RAI Volume 3, Chapter 2.2.1.3.13, First Set, Number 5:

Provide a technical basis to support the assumption that radionuclide diffusion characteristics are the same in basaltic tephra as in ambient soils. This information is needed to determine compliance with 10 CFR 63.114(a)(1, 2).

RAI Volume 3, Chapter 2.2.1.3.13, First Set, Number 6:

RAI Volume 3, Chapter 2.2.1.3.13, First Set, Number 7:

Figure 1. Contribution to Mean Annual Dose from the Inhalation of Airborne Particles and the Remaining Exposure Pathways for (a) 10,000 Years and (b) 1,000,000 Years after Repository Closure

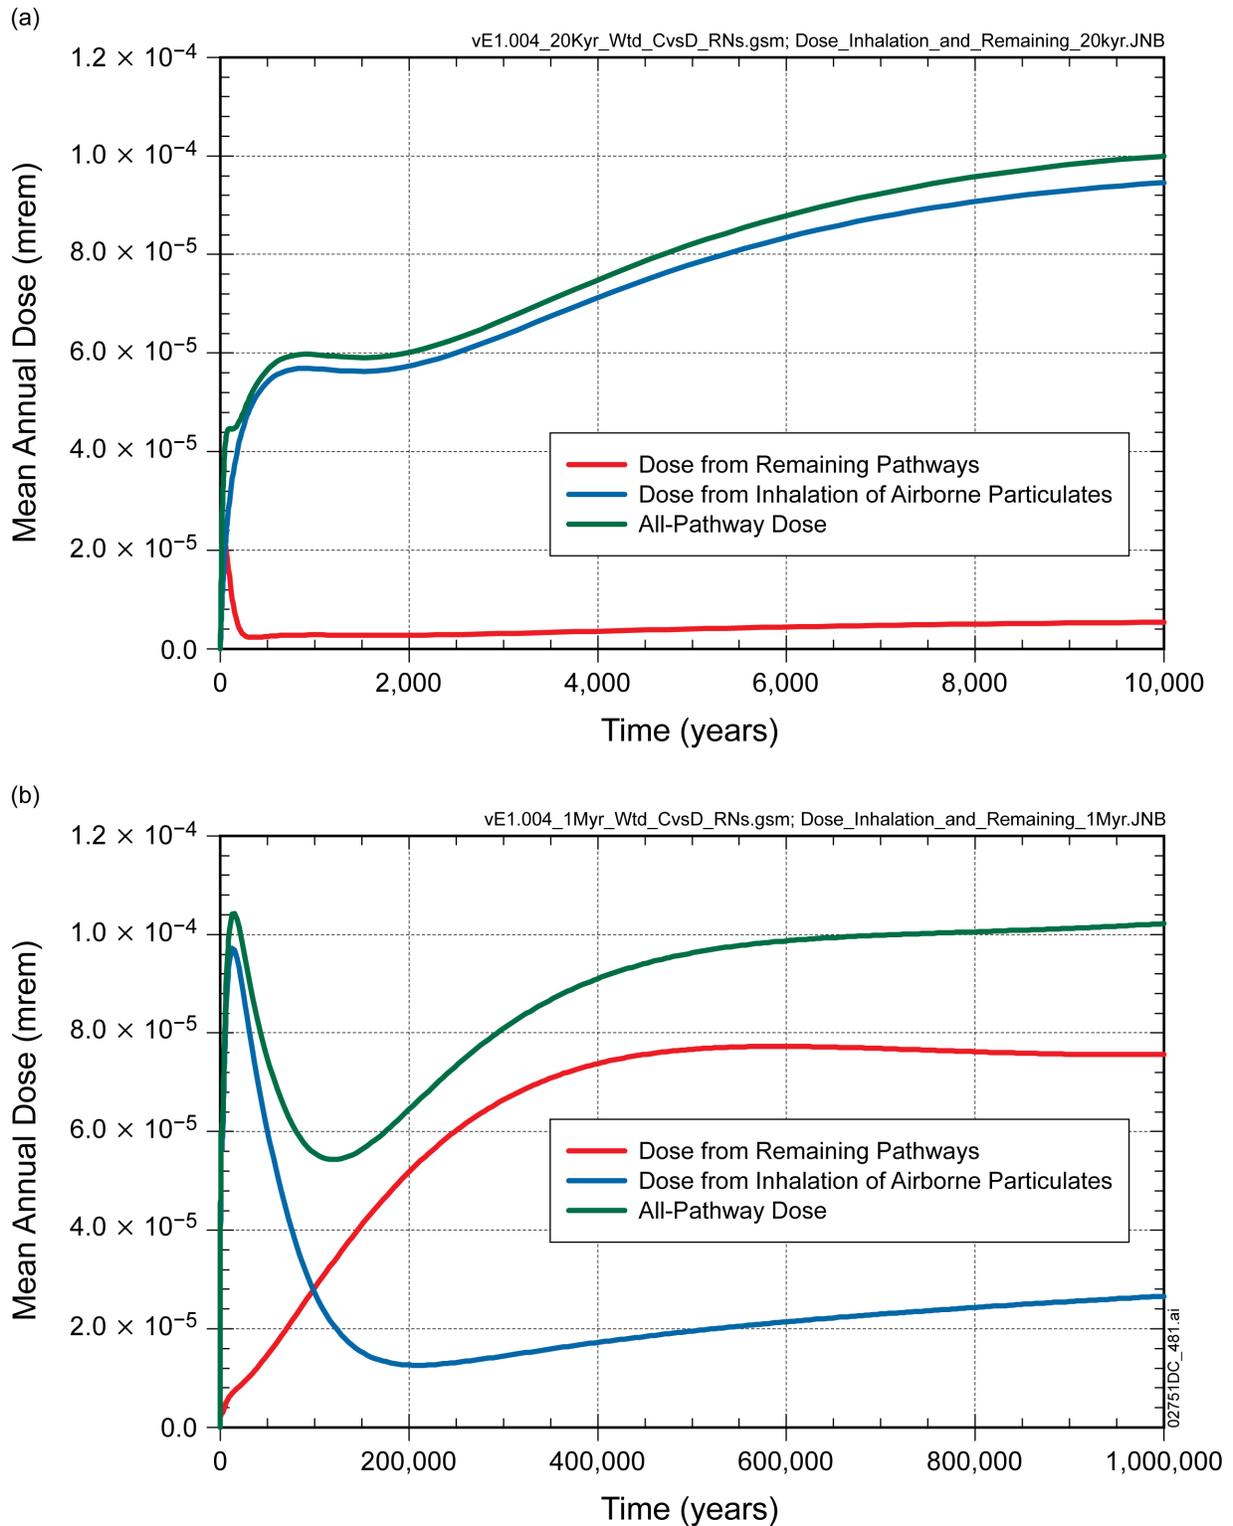
Provide additional information on airborne waste-contaminated particle concentrations over replenished fluvial deposits to justify the parameter values for long-term airborne mass loads at the Fortymile Wash alluvial fan. Provide information to demonstrate that the exposure times for active outdoor conditions includes time spent by the reasonably maximally exposed individual (RMEI) walking outdoors on undisturbed deposits. This information is needed to determine compliance with 10 CFR 63.114(a)(1, 2).

Figure 1 compares the mean annual dose from inhalation of airborne particles to the mean annual dose from the remaining pathways (ingestion of foods, external exposure, and inhalation of radon decay products) for 10,000 years (Figure 1(a)) and 1,000,000 years (Figure 1(b)). For 10,000 years, inhalation of airborne particles is a dominant contributor to mean annual dose because of the relatively high levels of radionuclides, such as isotopes of plutonium and americium, which have a high inhalation dose contribution. With time, the concentration of these radionuclides decreases because of their relatively short half-lives, and the dose contribution from other radionuclides, such as ^{226}Ra , ^{229}Th , ^{237}Np , and ^{126}Sn , becomes more important.

Figure 1. Relative Contribution to Total Mean Annual Dose from Direct Deposition on Interchannel Divides and from Redistribution of Contaminated Tephra in Distributary Channels for (a) 10,000 Years and (b) 1,000,000 Years after Repository Closure

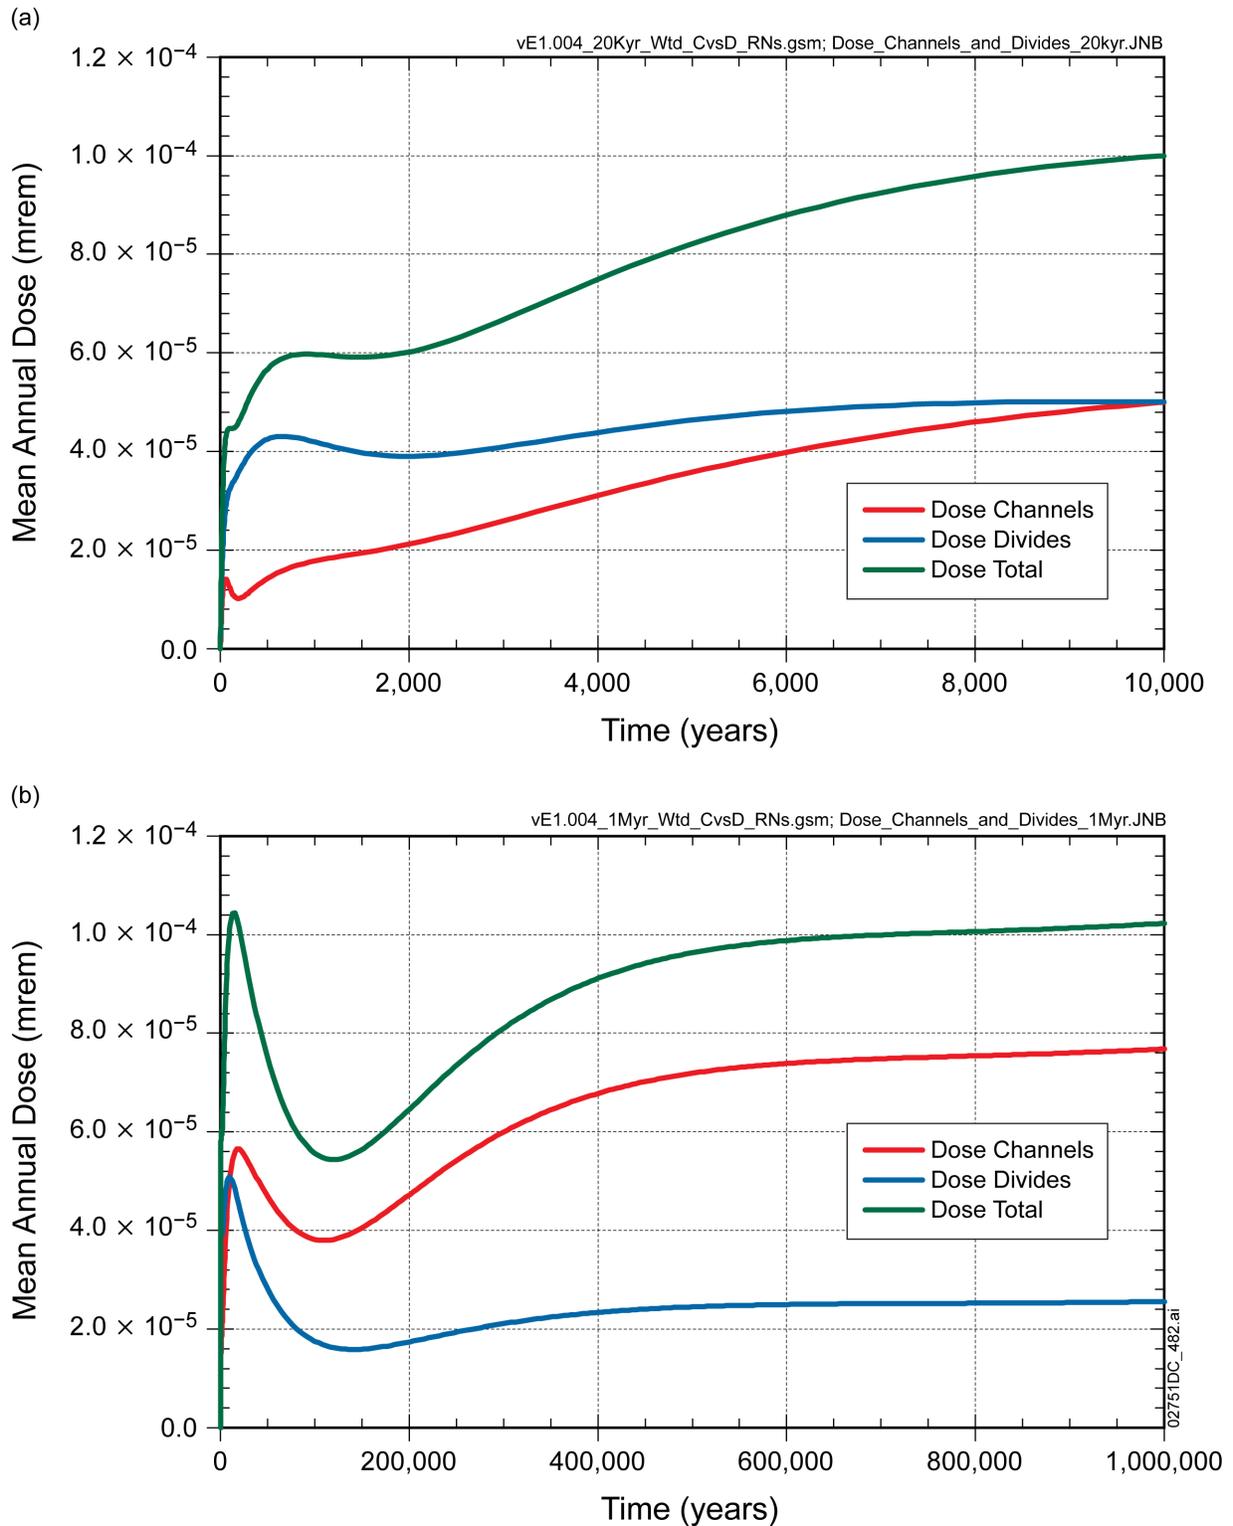
Provide information on airborne resuspension of waste-contaminated particles from distributary channels and interchannel deposits and surfaces at the Fortymile Wash alluvial fan. Justify the assumption that inhalation exposure to radionuclides in channels and on interchannel divides is proportional to their respective fractions of the total fan surface area. This information is needed to determine compliance with 10 CFR 63.114(a)(1, 2).

For the 10,000-year time period, dose calculated from interchannel divides is greater than dose calculated from distributary channels. Both dose components are dominated by the inhalation of contaminated airborne particles (see response to RAI 3.2.2.1.3.13-006, Figure 1). The inhalation dose on the interchannel divides is greater than in the distributary channels due to the higher radionuclide concentration in the resuspendable layer of soil on the divides. For the 10,000-year time period (Figure 1(a)), radionuclide concentration in the resuspendable layer, which contributes to the inhalation dose, is greater on the interchannel divides. The primary reason for this is that the redistribution of initial contaminated tephra into the soil on the divides is only through diffusion; whereas in the distributary channels, mixing of contaminated tephra with uncontaminated channel sediments by fluvial scour results in lower initial concentrations of radionuclides in the resuspendable layer of soil, and thus lower inhalation dose. The differences in the radionuclide concentration with soil depth in the distributary channels and on the interchannel divides result from the different initial deposition (by tephra fall and redistribution) and different values of parameters affecting the transport within the soil (e.g., scour depth in distributary channels compared to permeable depth on interchannel divides). On interchannel divides, contaminated tephra is considered to be deposited only from primary tephra fall. Radionuclides within this tephra fall are initially concentrated at the surface, but then diffuse

After 10,000 years (Figure 1(b)), dose from distributary channels becomes a major contributor to the total annual dose. The reason is the same as that for the decreased importance of the inhalation exposure pathway in the long term, discussed in the response to RAI 3.2.2.1.3.13-006. For 10,000 years, inhalation of airborne particles is a dominant contributor to mean annual dose because of the relatively high levels of radionuclides, such as ^{239}Pu , ^{240}Pu , and ^{243}Am , which have a high inhalation dose contribution. With time, the concentration of these radionuclides decreases because of their relatively short half-lives and the absence of ingrowth, and the dose contribution from other radionuclides, such as ^{226}Ra , ^{229}Th , and ^{237}Np , becomes much more important in part because of the ingrowth of these radionuclides from their long-lived parents. There is more ^{226}Ra in the surface soil layer (within the tillage depth) in the distributary channels than on the interchannel divides because the channels receive fluvially redistributed radionuclides in addition to the primary tephra fall, and the biosphere process model conservatively assumes that all ^{222}Rn produced from ^{226}Ra decay in this layer is released from the soil (SNL 2007, Section 6.5.2.2). Therefore, the long-term dose associated the channels will be higher.

Figure 1. Maps Showing Areas (red) Where the Local Slope Exceeds a Critical Slope Value for the Upper Drainage Basin Domain

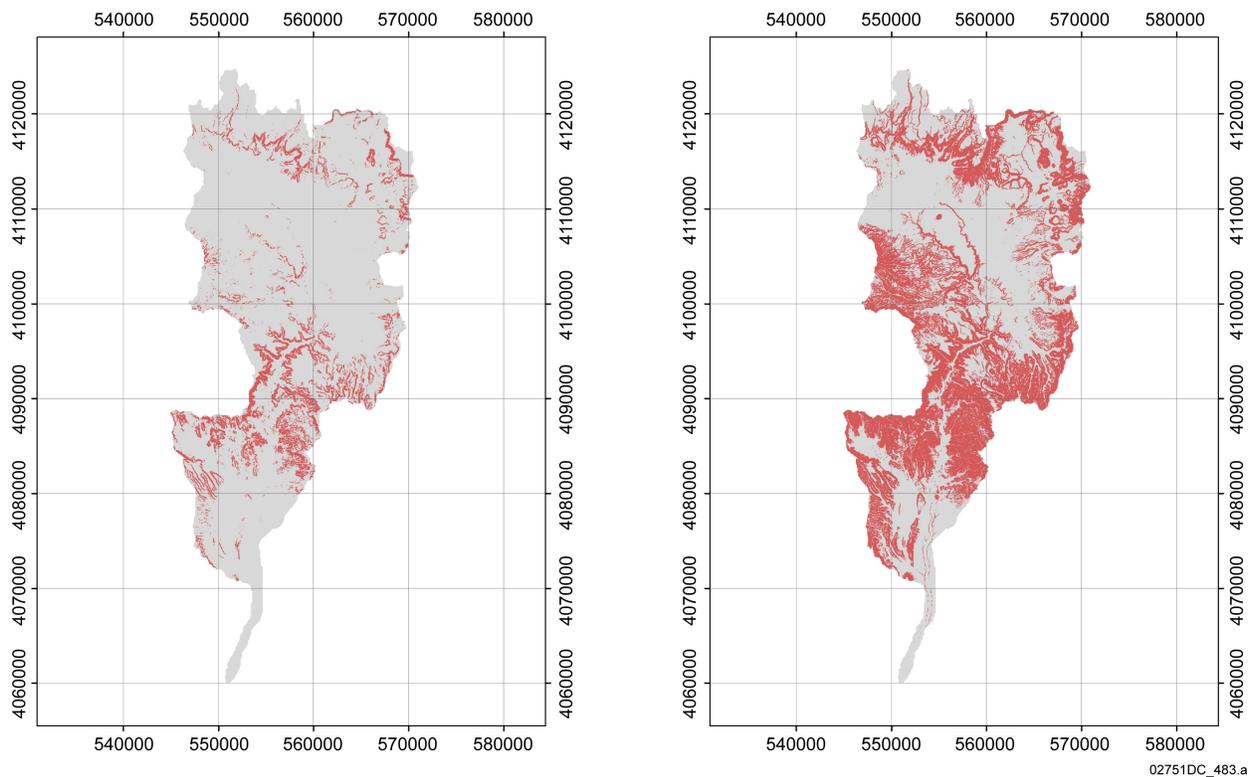
Explain how spatial grid sizes in the abstracted model adequately account for variations in the actual topography and do not smooth out steeper slopes, thereby reducing the potential for tephra mobilization. Provide additional information on how data from the selected analog sites and their incorporation into the DOE model account for uncertainty in potential future conditions for tephra erosion at Yucca Mountain. This information is needed to determine compliance with 10 CFR 63.114(a)(1, 2).

This relationship occurs because as the critical slope value decreases, the area of the basin whose slopes are greater than the critical slope, increases (SNL 2007, Figure 6.5.2-2; Figure 1), and the amount of material mobilized increases. That is, Figure 1 shows that the amount of mobilized tephra is controlled by the active slope area of the drainage basin, which increases as the critical slope decreases.

Figure 1. Upward-Concentrated Particle Distribution from ASHPLUME

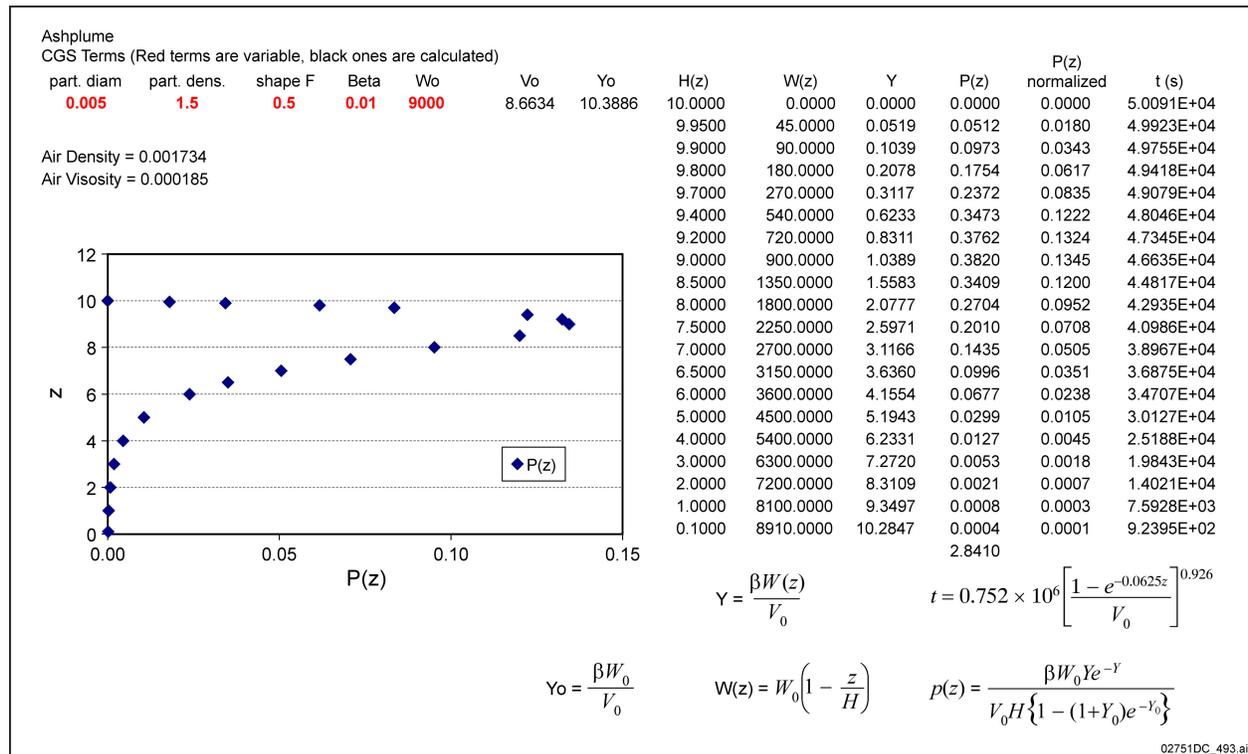
Provide additional justification for the parameter distributions used for the column diffusion coefficient and the magma partitioning factor in the DOE Ashplume model. This information is needed to determine compliance with 10 CFR 63.114(a)(1, 2).

DOE should justify the use of a column diffusion coefficient and magma partitioning factor with values less than 0.3 and explain how values less than 0.3 are consistent with the DOE conceptual model of a violent Strombolian eruption column and downwind plume.

This anvil-cloud distribution can also result from small values of β for combinations of other Ashplume input parameters. The plot in Figure 1 illustrates the profile of particle mass in the initial eruption column vs. height (z , in km), as represented by the probability density function for particle diffusion out of the eruption column, $p(z)$ (SNL 2007a, p. 6-11). Referring to Ashplume input parameter ranges provided in *Atmospheric Dispersal and Deposition of Tephra from a Potential Volcanic Eruption at Yucca Mountain, Nevada* (SNL 2007a, Table 8-2), for small tephra particle diameters (e.g., 0.005 cm) and relatively high initial rise velocities (e.g., 9,000 cm/s), the use of values of β at the low end of its range (e.g., 0.01) is appropriate to develop the upward-concentrated particle distribution (Figure 1). Therefore, the low end of the range originally used by Suzuki (1983) and Jarzemba et al. (1997) is appropriate for use in Ashplume realizations for Yucca Mountain to develop mass loading for model eruptive columns representing violent Strombolian eruptions.

Figure 1. Schematic of Extent of Ashplume Model Study Area for This RAI Response

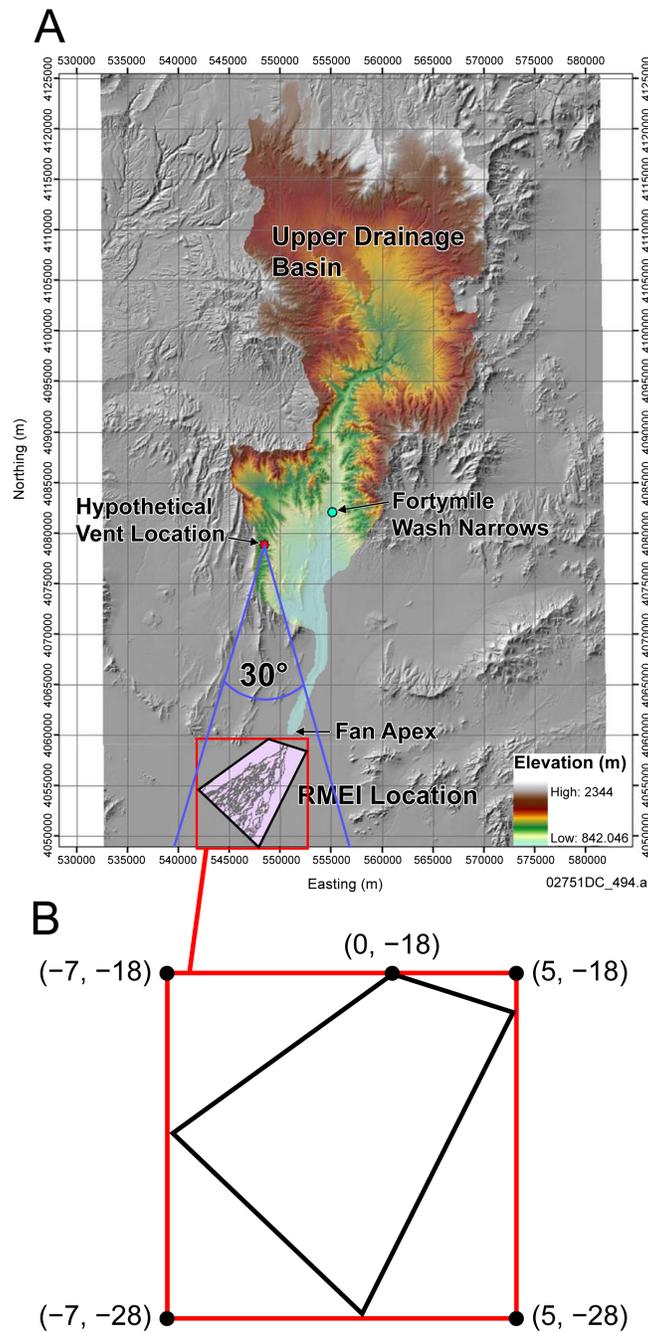
Provide additional information to show that using a point to model tephra deposition at the reasonably maximally exposed individual (receptor) location does not underestimate radiological dose. This information is needed to determine compliance with 10 CFR 63.114(a)(1, 2).

The appropriateness of a single point calculation of tephra deposition to represent conditions in the 33 km² RMEI location used in the FAR model (SNL 2007a, Section 6.5.4.1) is demonstrated here through the use of supplementary Ashplume model runs. These model runs are taken from the validated total system performance assessment (TSPA) model realizations (SNL 2008) in which the ASHPULME code calculated tephra and waste concentrations for a single point located 18 km south of the hypothetical eruption vent (Figure 1). The Ashplume realizations were repeated to assess concentrations at a grid of points that circumscribes the upper Fortymile Wash alluvial fan defined as the RMEI location for the purposes of the FAR model (Figure 1). The point at coordinates (0, -18), where TSPA model point values of tephra/waste areal concentrations were calculated, is included in this grid for comparison purposes. (The location of the RMEI is specified with respect to the groundwater transport of radionuclides as approximately 18 km due south of the repository along Fortymile Wash, as described in SNL 2007b, p. 6-32.)
